Service News

JANUARY, 1951

ANNOUNCEMENT

FIGURE T-1

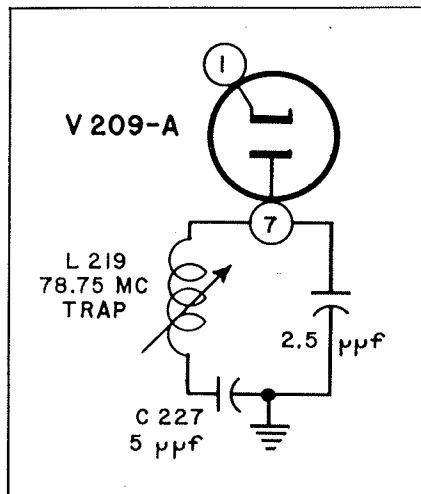
Probable Fault: The seventh harmonic (183.75) of the video if (26.25) combines with the video carrier of channel 8 (181.25) to produce a 2.5-mc beat.

Remedy: Connect a 2.5-mmF capacitor from pin 7 of the video detector (V209-A) to ground as shown in figure T-1.

FIGURE T-2

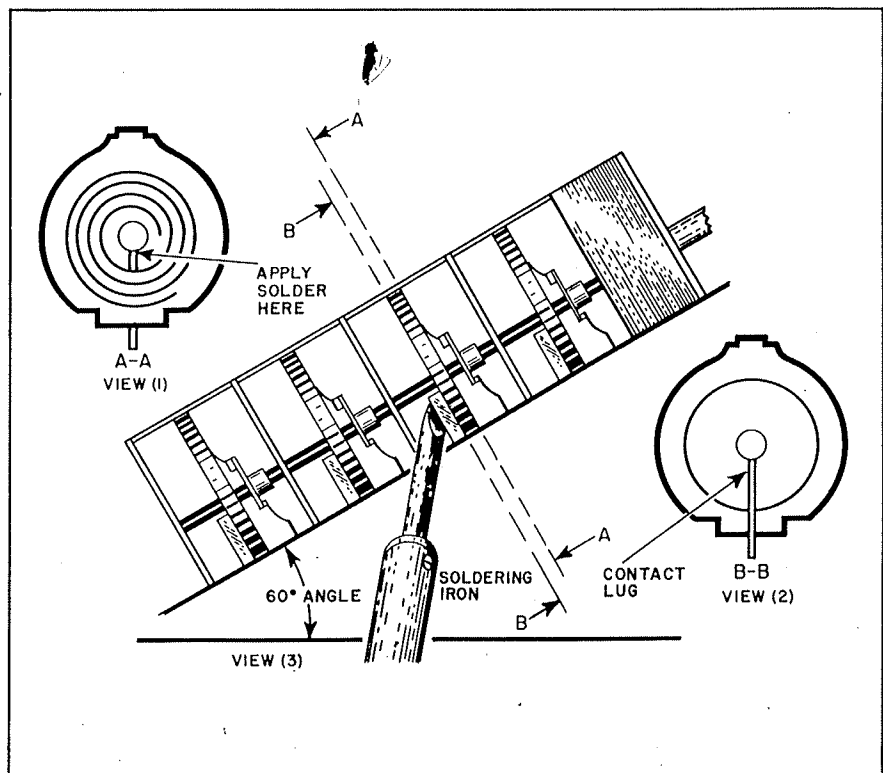
Remedy: The following procedure can be used with *extreme caution*, to correct this condition.

2. Tilt the Inputuner chassis so that the shaft of the Inductuner is at an angle of 60° , with the front of the chassis up.
3. Using a 150-watt soldering iron, with a $\frac{1}{4}$ " tip, heat the lug contacting the inner end of each spiral coil, as shown in (2) and (3) of figure T-2. Be sure that your soldering iron is clean and well tinned.
4. After each contact lug is heated, apply a very small amount of solder to the point where the lug and

the spiral meet, as shown in (1) of figure T-2. The solder should be applied near the upper end of the lug and allowed to run down to the spiral. In most cases, the solder already present will be sufficient.

FIGURE P-1

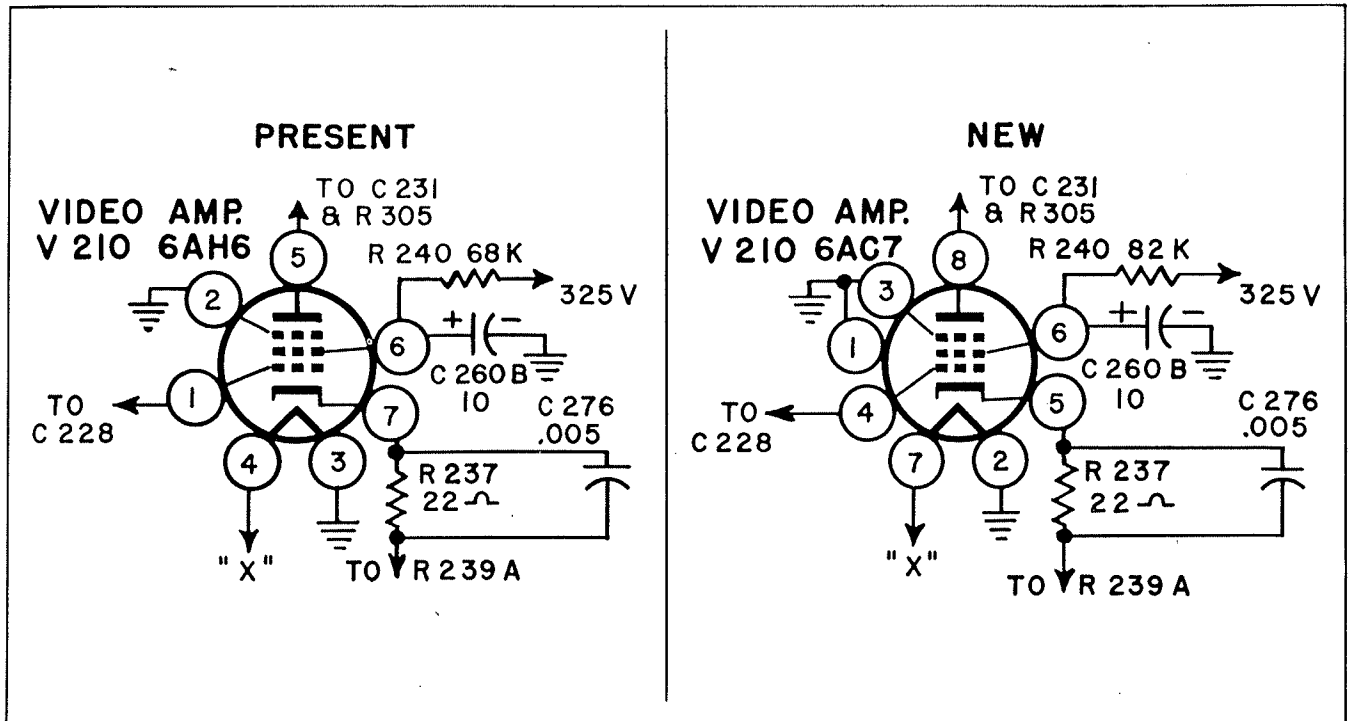
Due to a shortage of 6AH6 electron tubes, it has been found necessary to make the following change.

1. Rewire V210 as shown in figure P-1.
2. Replace V210, 6AH6 with 6AC7.

Figure P-1. Change No. 41, RA-109A.

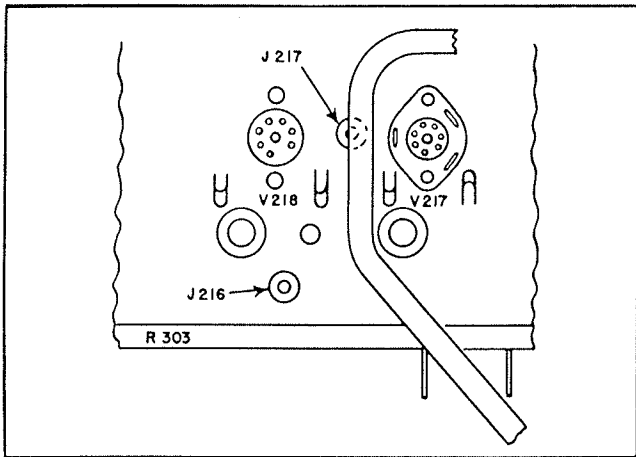
Change No. 41 (ECN-4809)

Mount the two jacks, J216 and J217 as shown in figure P1.

Figure P-2. Change No. 39, RA-112A - RA-113.

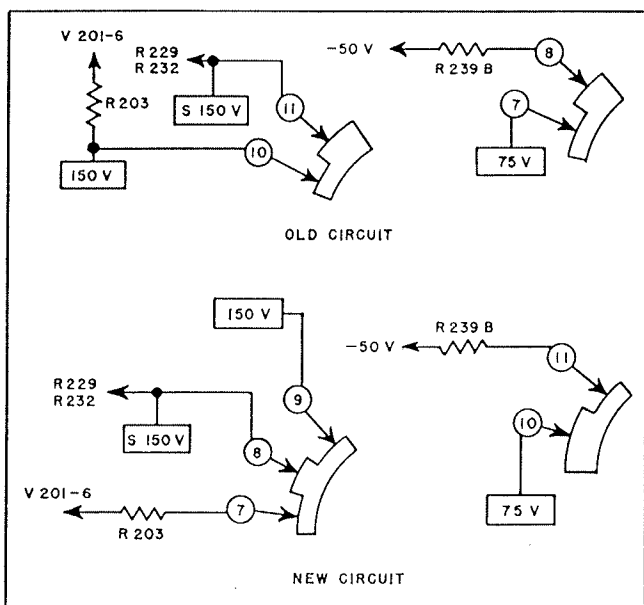
To eliminate f-m pickup when the Teleset is being used for phonograph reproduction. This pickup occurs in areas where very strong f-m signals are present and is coupled to the first sound amplifier through the stray capacitance of S201. A position is added to this switch to remove the B+ from the screen of the first sound i.f., V201.

Replace and rewire S201 as shown in figure P2. Connections not shown remain the same.

Figure P-3. Change No. 40, RA-112A - RA-113.

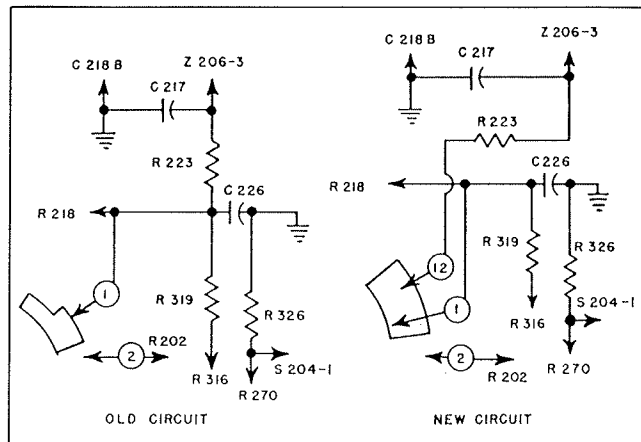
Change No. 40 (ECN-4690)

1. Change S201
2. Disconnect R223 from junction of C226 and R319 and connect this end to S201-12, as shown in figure P3.

Figure M-1.

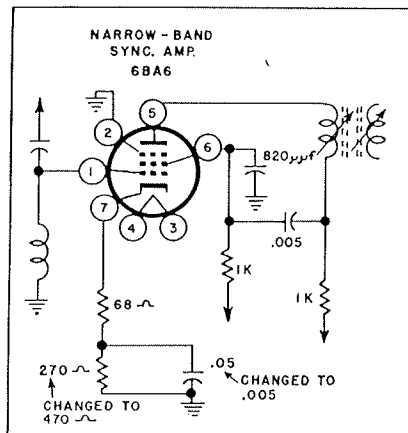
The proper procedure to use in attacking a receiver which is exhibiting horizontal pull is as follows:

d. Remove the .05 mfd bypass capacitor in the cathode circuit of the narrow-band sync amplifier and replace it with a .005 mfd capacitor, as shown in figure M-1. The symbol number of this capacitor is C312 in the RA-109A; and C287 in the RA-112A, RA-113, RA-117A and RA-120.

Figure M-2. A: before changes; B: after changes.

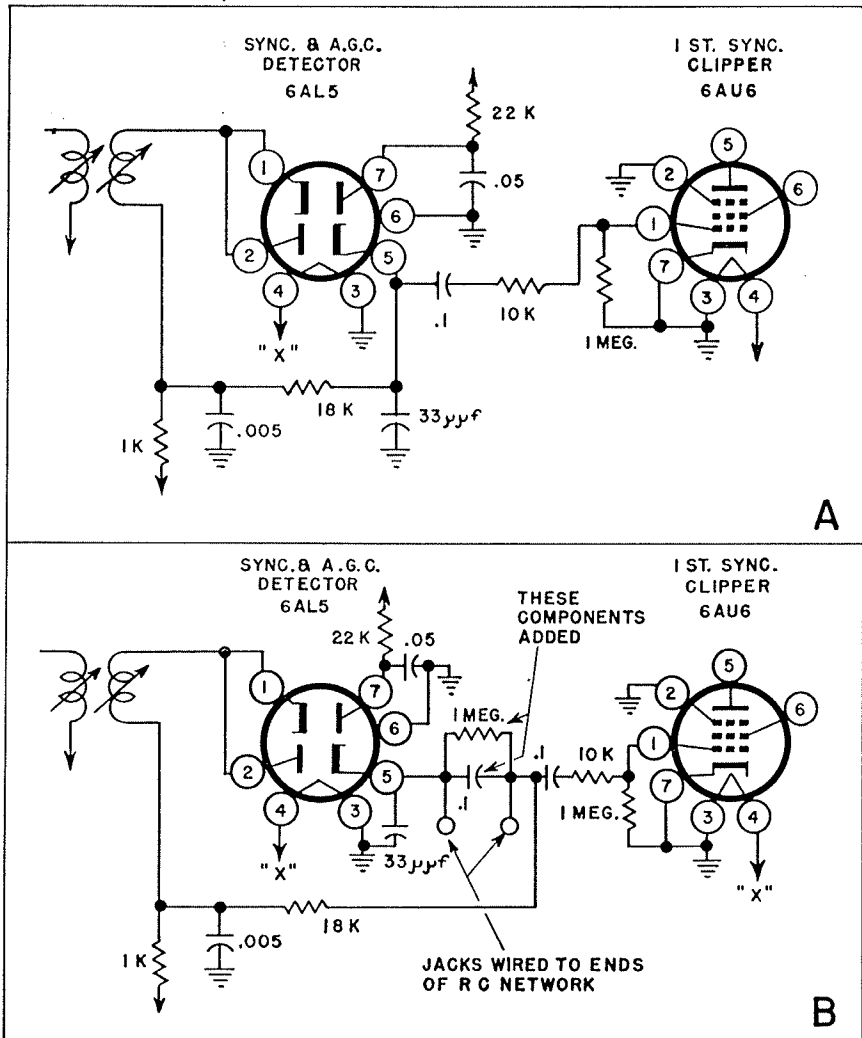
- b. Remove the ends of the 18K resistor and the 0.1 mfd capacitor from pin 5 of the sync detector socket. The symbol numbers of these components are R275 and C249 in the RA-109A; and R249 and C261 in the RA-112A, RA-113, RA-117A and RA-120. Connect a parallel network, consisting of a 0.1 mfd capacitor and a 1 meg resistor, between pin 5 of the socket and the ends of the 18K resistor and 0.1 mfd capacitor, as shown in figure M-2.
- c. If jacks have been mounted on the chassis and wired to the ends of R284, they should be rewired, one to each end of the RC network as shown in figure M-2. If the jacks are not present, it

Figure G-1

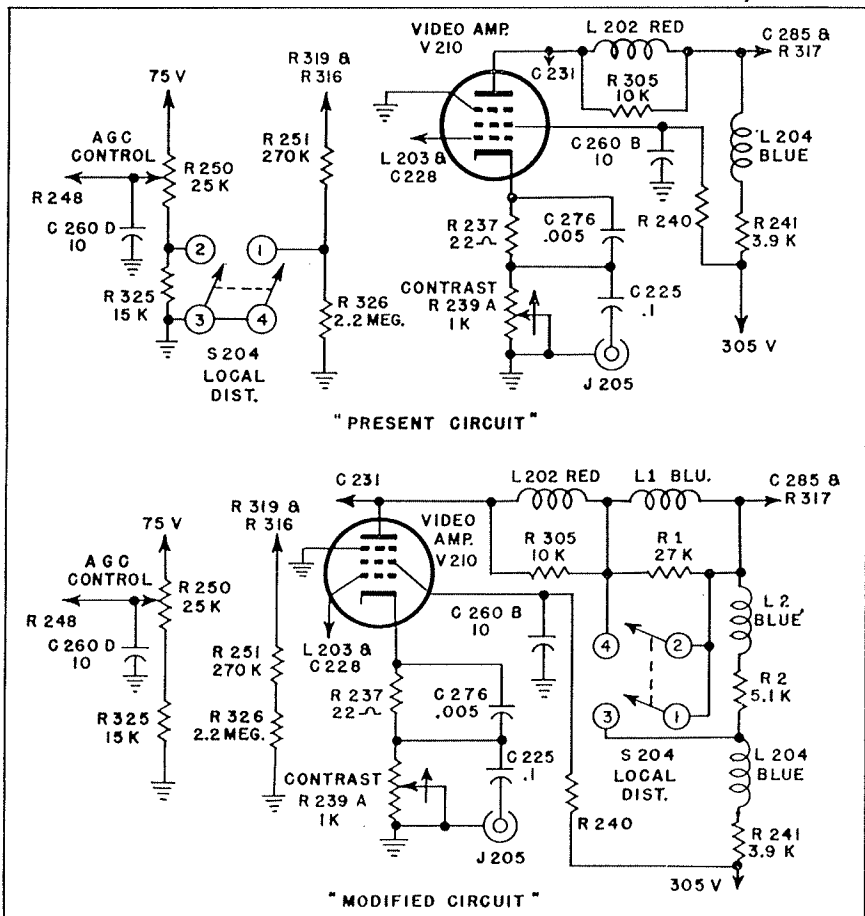
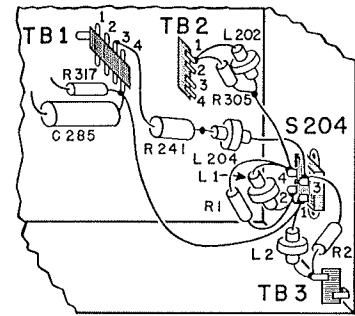
In weak signal locations it is sometimes impossible to obtain a satisfactory picture with even the most elaborate antenna installation. The modification described here will increase the gain of RA-112A, RA-113, and RA-117 Telesets sufficiently to make it possible to obtain an acceptable picture in many such cases. The additional gain is obtained by increasing the plate load resistance of the video amplifier, as shown in Figure G-1. The increased plate resistance reduces the bandwidth of the stage necessitating additional high-frequency peaking. While the additional peaking partially compensates for the loss in bandwidth, some reduction occurs as a result of

1. Remove the black lead running from ground to S201-3 and -4. Remove the connection between S204-3 and -4 (the Local-Distant switch).
2. Remove the orange lead running between R250 (the a-g-c control) and S204-2.
3. Remove the purple lead running from S204-1 to the junction of R326 and R251 (near V220).
4. Disconnect L202 and R305 from junction of C285, R317 and L204.
5. Connect the free ends of L202 and R305 together, and connect this junction to S204-4, as shown in Figure G-2.
6. Connect R1 and L1 in parallel between S204-2 and S204-4.

7. Disconnect L204 from the junction of C285 and R317.
8. Disconnect the junction of L204 and R241 from the terminal strip.
9. Connect L204 between the free end of R241 and S204-3.
10. Mount a one position terminal strip in the corner of the chassis nearest the Local-Distant switch. The sheet metal screw in the chassis at this point may be removed and the terminal strip mounted with a machine screw, nut, and lockwasher.
11. Run a lead from the junction of C285 and R317 to S204-1 and place a jumper between S204-1 and S204-2.
12. Connect R2 (5.1K) from S204-3 to the terminal strip added in step 10.
13. Connect L2 from the terminal strip added in step 10 to S204-1.

Figure P-1. Change No. 52, RA-112A - RA-113.

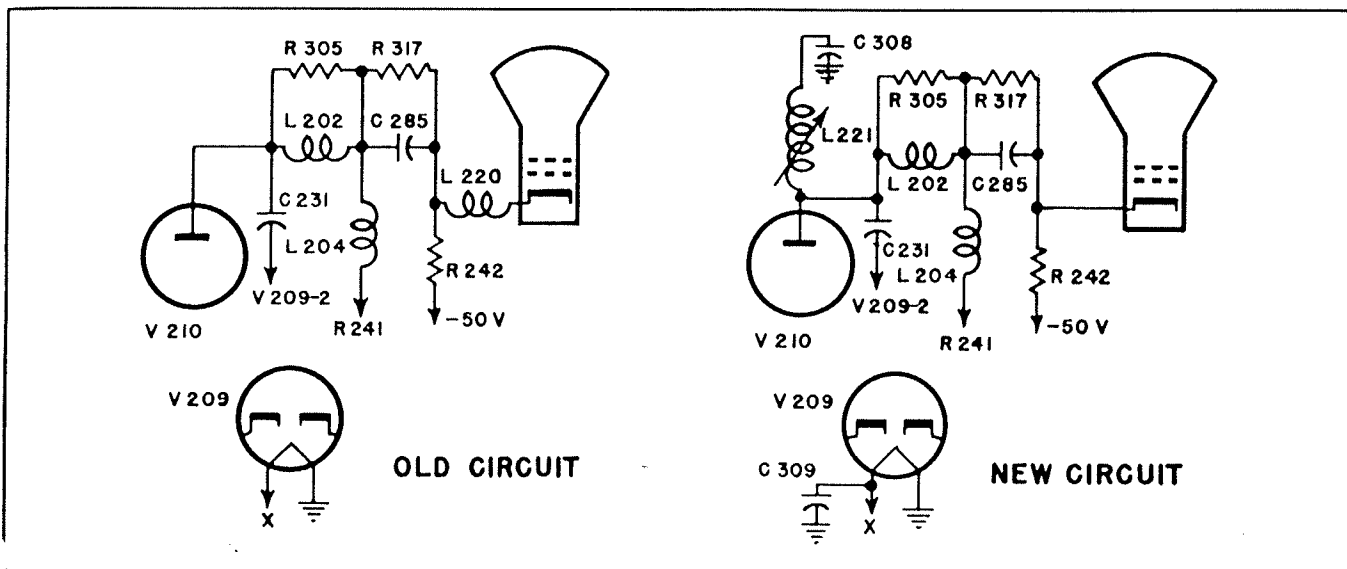
Reason:
To increase the effectiveness of the Channel 5 beat interference traps added by Change No. 33. The beat was caused by the 3rd harmonic (78.75 mcs) of the video i-f carrier (26.25 mcs) which was radiated from the CRT leads and combined with the carrier of Channel 5 (77.25 mcs) to produce a 1.5 mc beat. The fixed trap in the cathode lead of the CRT is deleted and a tuneable trap is added from the plate of the video amplifier to ground. A 100 mmf capacitor is added from the filament of V209 to ground to prevent coupling, between V209A the video detector, and V209B, the d-c restorer, through their common filament. The new circuits are illustrated in Figure P-1.

- Procedure:**
1. Delete L220.
 2. Connect the free end of brown lead, previously connected to L220, to the junction of C285, R242 and R317.
 3. Rotate the terminal strip to which the jumper from the plate of V210 attaches, about 15° away from V210.
 4. In the space made available by step 3, make a hole as shown in Figure P-2. If a punch is not available, the hole may be drilled using 5/16 inch and 3/64 inch drills.
 5. Mount L221 in the hole.
 6. Connect the side of L221, nearest the terminal board, to the junction of the jumper from the plate of V210, R305 and L202.
 7. Connect C308 from the other side of L221 to the nearest ground lug.
 8. Add C309 from V209-4 to ground, keeping its leads about one-half inch long.
 9. Tune the receiver to Channel 5 and, observing the beat

interference, tune L219 and L221 until the interference disappears.

Figure T-1

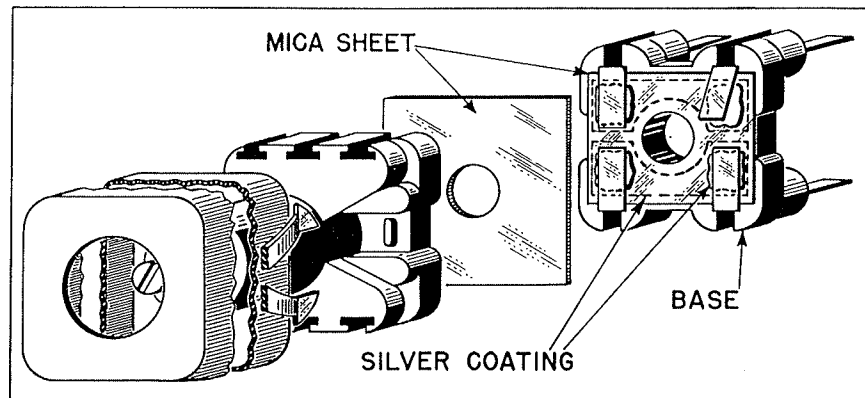
Probable Fault: An open capacitor in one of the sound i-f transformers (Z201 in RA-112A, RA-113 and RA-117, Z201 or Z202 in RA-109A, RA-116A and RA-119). Two capacitors are mounted in the bottom of each of these transformers. The capacitors consist of a small sheet of mica which acts as the dielectric of both capacitors, with silver coatings on both sides forming the plates as shown in figure T-1. The transformer terminals are cemented to these plates. Humidity or vibration can cause a terminal to separate from its associated plate and open the capacitor. During alignment the stage will show low gain and the transformer will not peak at the sound intermediate frequency.

Remedy: Replace the transformer with type having coated capacitor wire or remove capacitor wire and connect a 1.5 mmf ceramic capacitor across the upper ends of the transformer windings.
